## Product Change Notification

### PCN-PCC-276-2017

Business Unit	Product Line Code	Type of Change	Action	Date of Issue
PCC - PCB Connectors	AAA	Product Change Notification	Notify Distributors and Field	2/3/2017

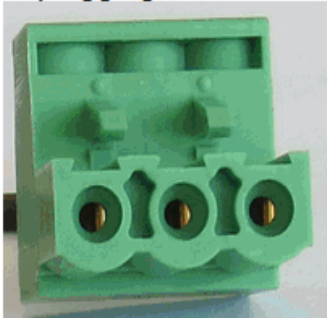
Changed the metal part inside from a complete gold-plated surface to a partially gold-plated surface. This change does not increase the contact resistance. Also Dimensions and technical data are not affected by this modification. The following part numbers were also affected:
